New Port Facility Falkland Islands

Supporting statement to variation of condition application

Revision	Date	Description	Prep	Check	App
P02	24-Aug-2022	Final for planning submission	MS	RP	MS

Contract No:	Doc No:	Status	Revision
BAM	BAS.2051	BAS2051-RHD-ZZ-ZZ-FN-YE-5037	S4	P02
RHDHV	PB7829	PB7829-RHD-ZZ-ZZ-FN-YE-5037	S4	P02

DRAWN	JBW	CHECKED	PPV	APPROVED	DP
DATE	10/02/2021	SCALE	1:500	RHDHV DRAWING No.	
BAM DRAWING No.	PB7829-RHD-CE-LS-DR-C-0028	SUITABILITY	S4	REVISION	P04

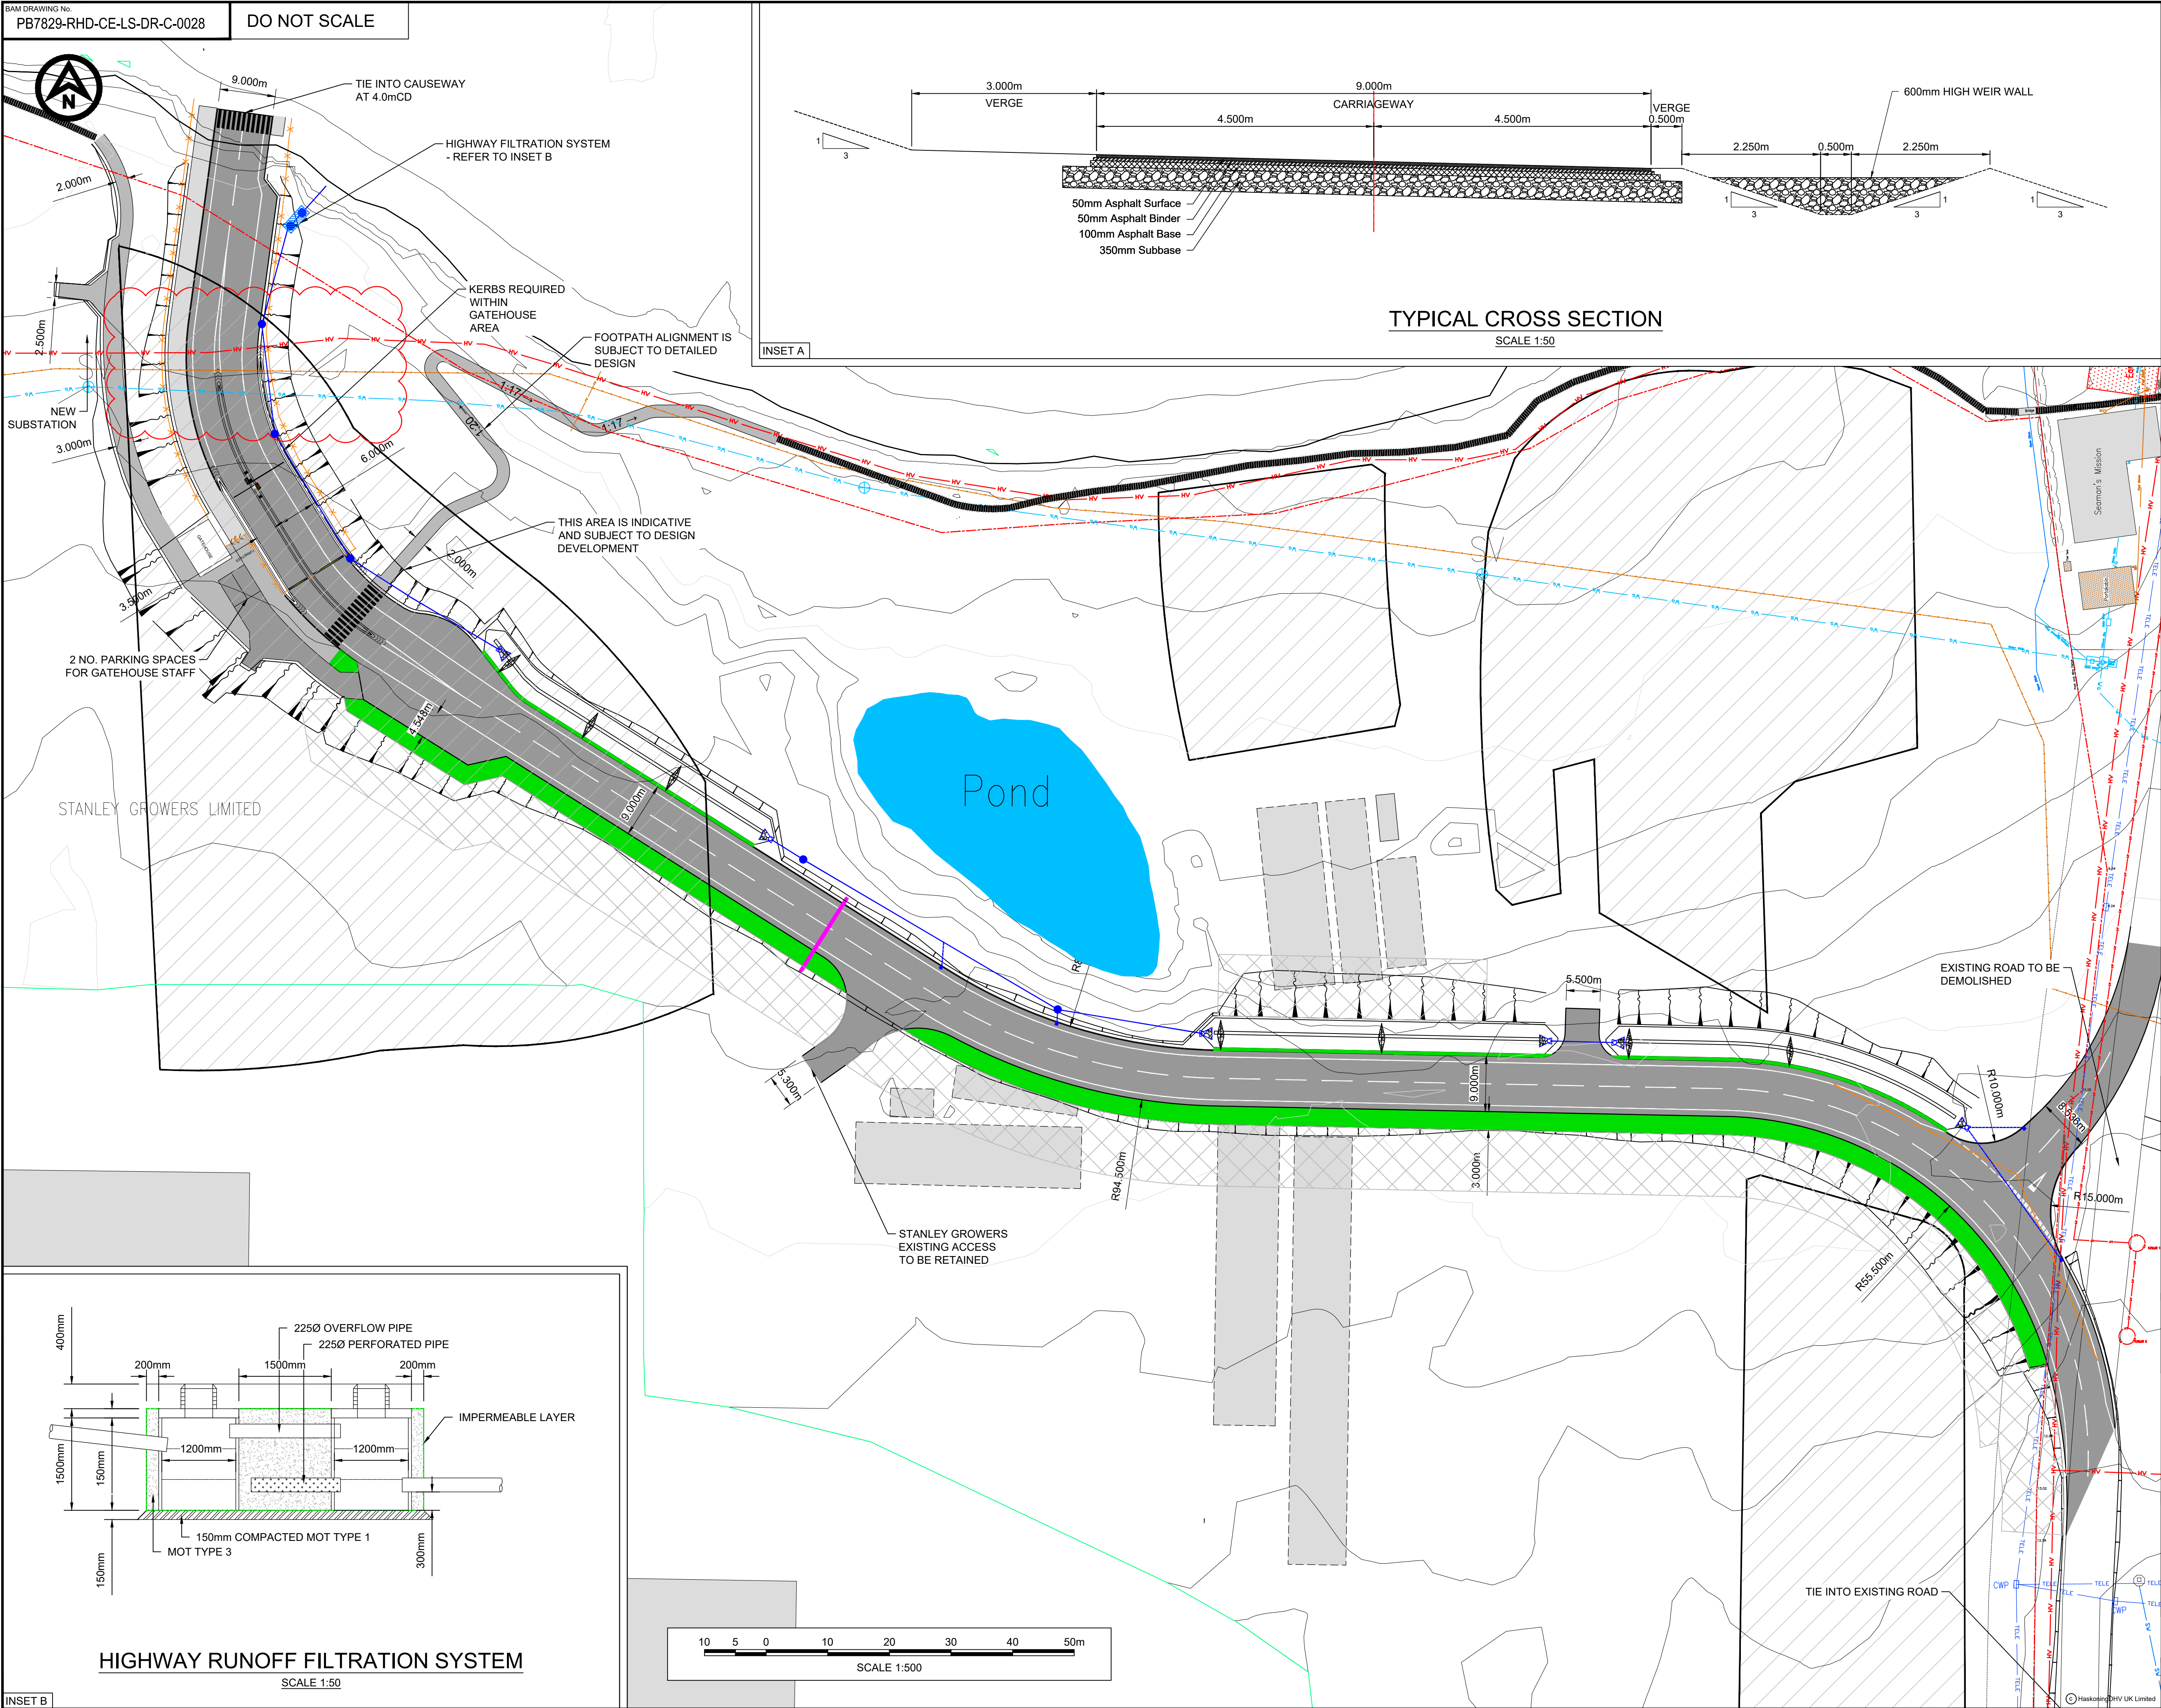
Variation to	Details	Primary condition or content affected
Access road	<p>The area of impacted land at Stanley Growers is reduced due to the minor amendment to the track to reflect removal of HGV access to Area 11, which is now not required.</p> <p>Overall, less land is affected for the construction stage and there is a minor reduction in area of land permanently affected. The effect of this is that there is a reduced volume of topsoil that requires stockpiling and is available for use for improvement of other areas of land.</p>	Condition 2 – Approved Plans
Drawings	Approved Plans updated, some of which are included as supporting drawings to the EIS	Condition 2 – Approved Plans
